CERTIFICATE OF APPROPRIATENESS

Property: 1917 Crockett St, Lot 1, Block 314, Shearn Addition Subdivision. The property is a vacant 2,315 square foot (47' x 49'-3") corner lot.

Proposal: New Construction – Residence

Recommendation: Deferral

SOUTH ELEVATION

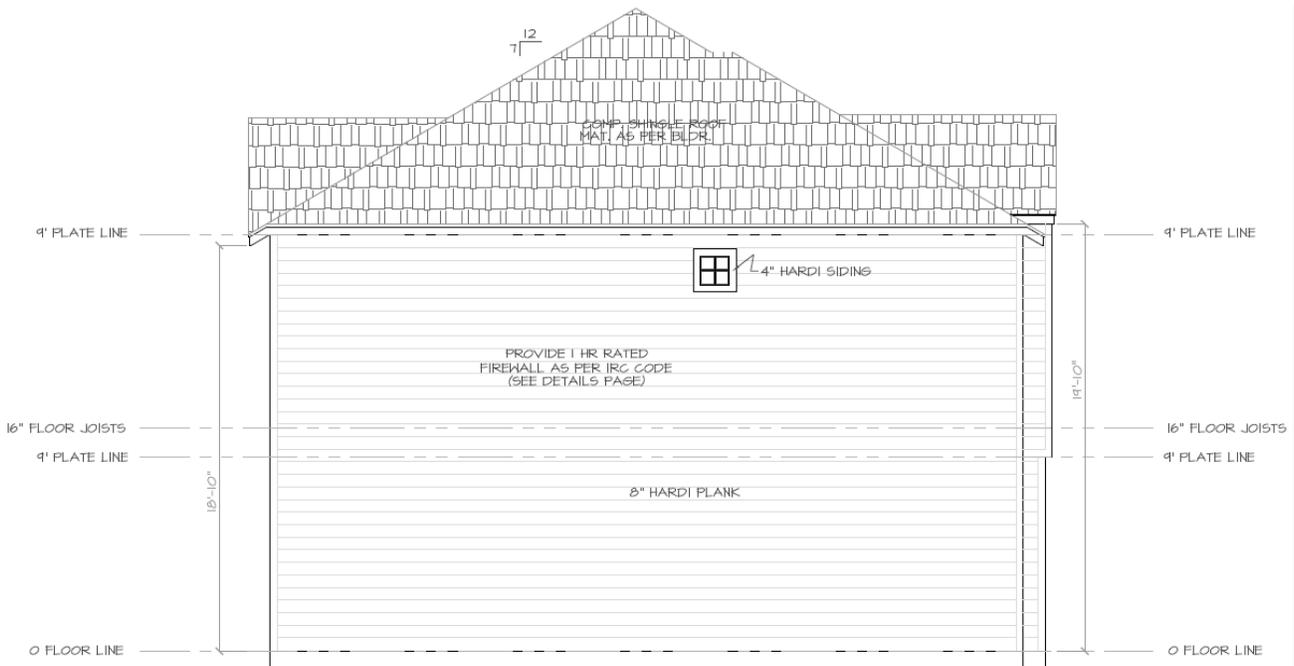
The south elevation is lacking window openings in keeping with typical contributing structures in the area. This two-story blank wall only 2' from the south property line does not meet Design Guidelines provisions requiring traditional solid-to-void proportions for walls to windows.
- (3) The scale and proportions of the new construction, including the relationship of the width and roofline, overall height, eave height, foundation height, porch height, roof shape, and roof pitch, and other dimensions to each other, must be compatible with the typical scale and proportions of existing contributing structures in the context area unless special circumstances, such as an atypical use, location, or lot size, warrant an atypical scale and proportions;

The draft Design Guidelines also require traditional solid-to-void proportions for walls to windows. The south elevation lacks window openings, which is not in keeping with typical contributing structures in the area and therefore does not meet this provision.

PROPOSED

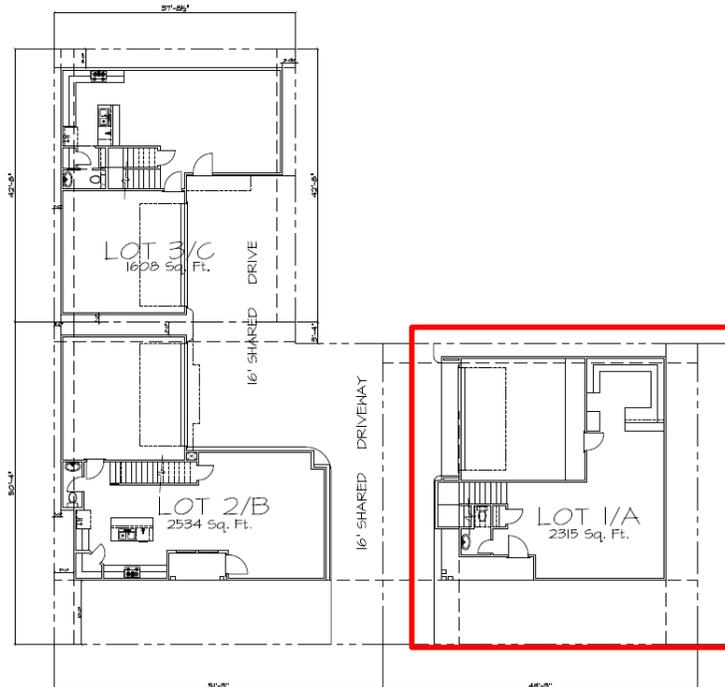
There is one contributing structure on this blockface that has a setback of 11'. The contributing structure on White Street has an approximate setback of 5'. The current proposal has a setback of 10' on Crockett and 5' on White Street. The setback on the south side is only 2' however, which is not a typical or appropriate setback.
- (2) The exterior features of the new construction must be compatible with the exterior features of existing contributing structures in the context area;
